MegaCore IP Library

Release Notes and Errata

MegaCore Library Version: 9.0
Document Version: 9.0.1
Document Date: 15 March 2009

Figure 14-1. 128-Bit Avalon-ST rx_st_data0 Cycle Definition for 3-DWord Header TLPs with QWord Aligned Addresses

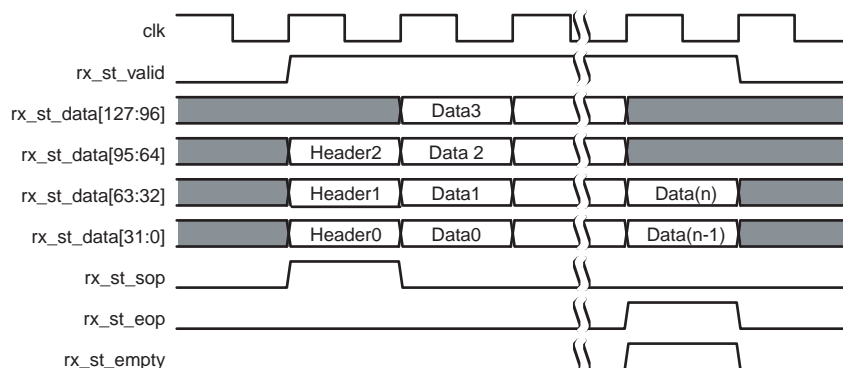
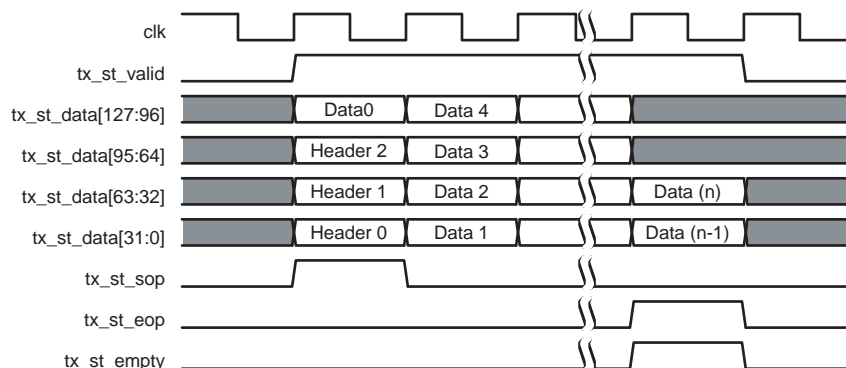
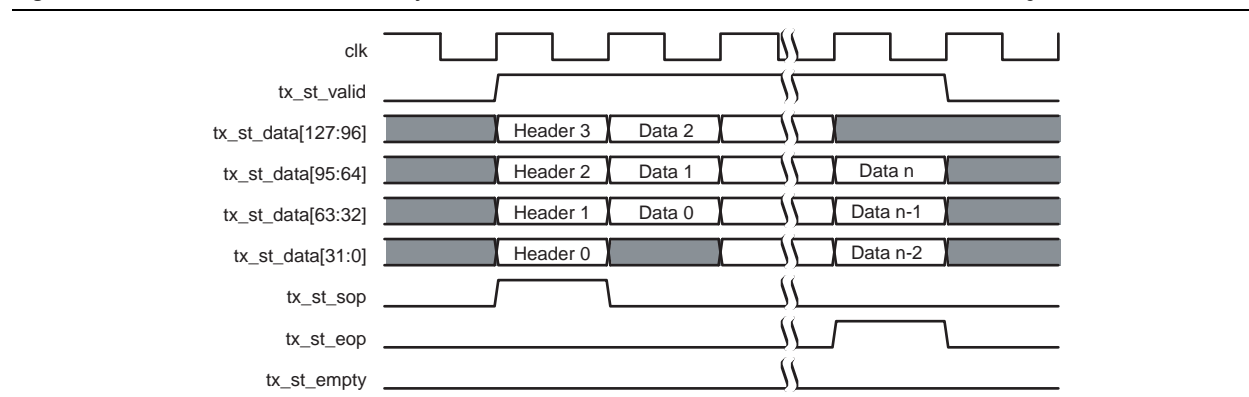
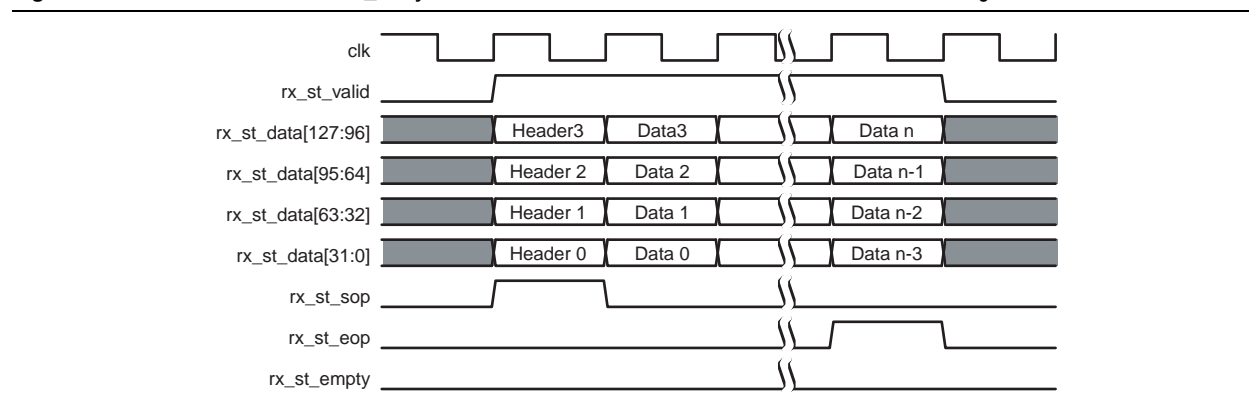
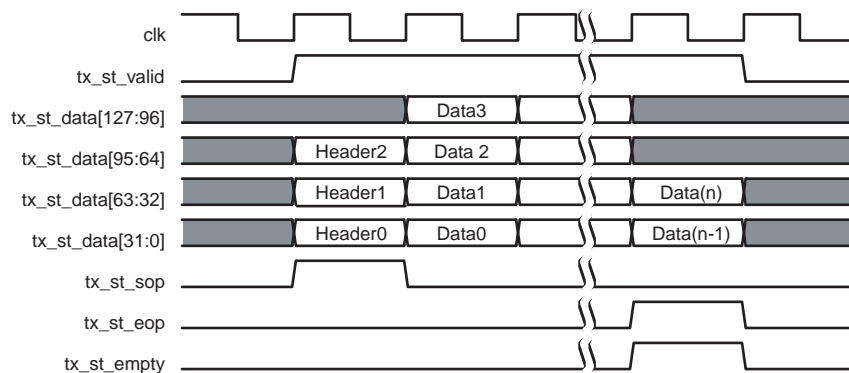
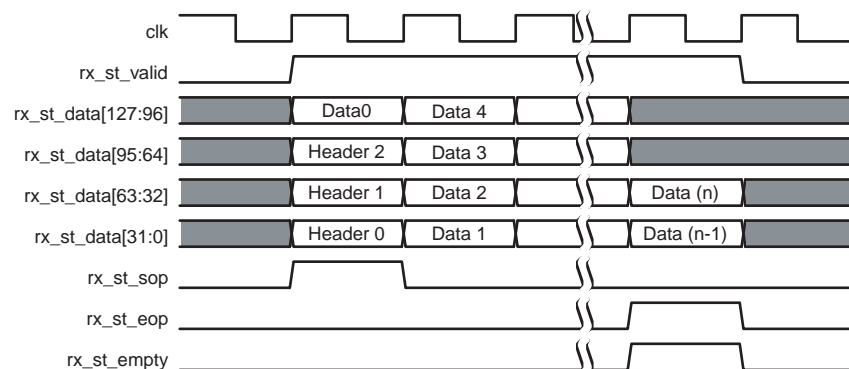
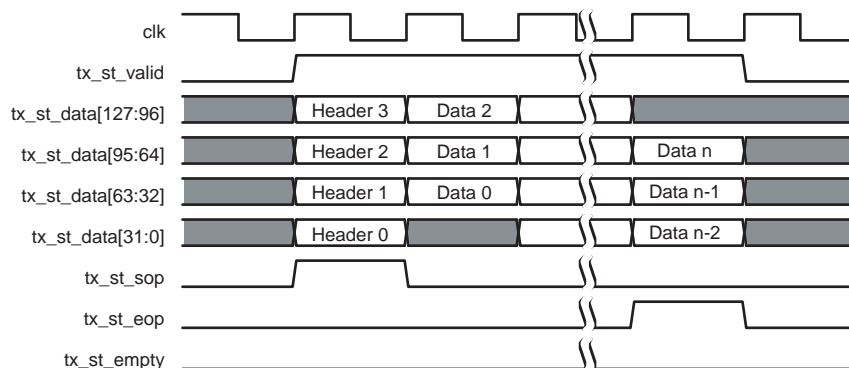
In 128-bit mode, the qwords in the timing diagrams are swapped. The correct order for Rx or Tx data[127:0] is {H3, H2, H1, H0}. The *PCI Express Compiler User Guide* shows data[127:0] as {H1, H0, H3, H2}. In addition, the rx_st_empty0 and tx_st_empty0 signals indicate that the TLP ends in the *lower* words of data. The corrected diagrams and text are given here.

Figure 14-1 shows the mapping of 128-bit Avalon-ST Rx packets to PCI Express TLPs for TLPs with a three dword header and qword aligned addresses.

Figure 14-2 shows the mapping of 128-bit Avalon-ST Rx packets to PCI Express TLPs for TLPs with a 3 dword header and non-qword aligned addresses.

Figure 14-3 shows the mapping of 128-bit Avalon-ST Rx packets to PCI Express TLPs for a four dword header with non-qword aligned addresses. In this example, `rx_st_empty` is low because the data ends in the upper 64 bits of `rx_st_data`.

Figure 14-4 shows the mapping of 128-bit Avalon-ST Rx packets to PCI Express TLPs for a four dword header with qword aligned addresses.

Figure 14-5 shows the mapping of 128-bit Avalon-ST Tx packets to PCI Express TLPs for a three dword header with qword aligned addresses.

Figure 14-6 shows the mapping of 128-bit Avalon-ST Tx packets to PCI Express TLPs for a 3 dword header with non-qword aligned addresses.

Figure 14-7 shows the mapping of 128-bit Avalon-ST Tx packets to PCI Express TLPs for a four dword header TLP with non-qword aligned addresses. In this example, tx_st_empty is low because the data ends in the upper 64 bits of tx_st_data.

Figure 16–1. DIP-4 Counter (Note 1)

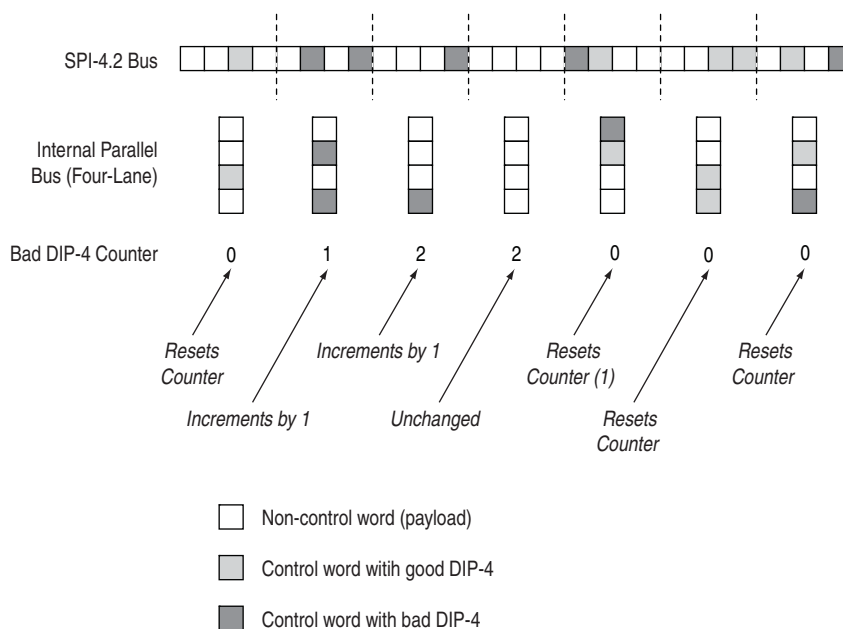
In particular, the following sentence has the incorrect “all” replaced by the correct “any”:

The following paragraph is correct:

If the `stat_rd_dip4_oos` signal is low, and all of the DIP-4s in the control words received in the current clock cycle (up to 8 in 128-bit mode) are errored, the bad counter is incremented by 1; otherwise it is reset to 0. If the bad counter reaches the `bad_level` threshold, the `stat_rd_dip4_oos` flag is asserted. A `bad_level` of 0 is invalid.

Figure 16–1 shows an example of the DIP-4 counter, where the receiver is in service state and bad threshold is 3.
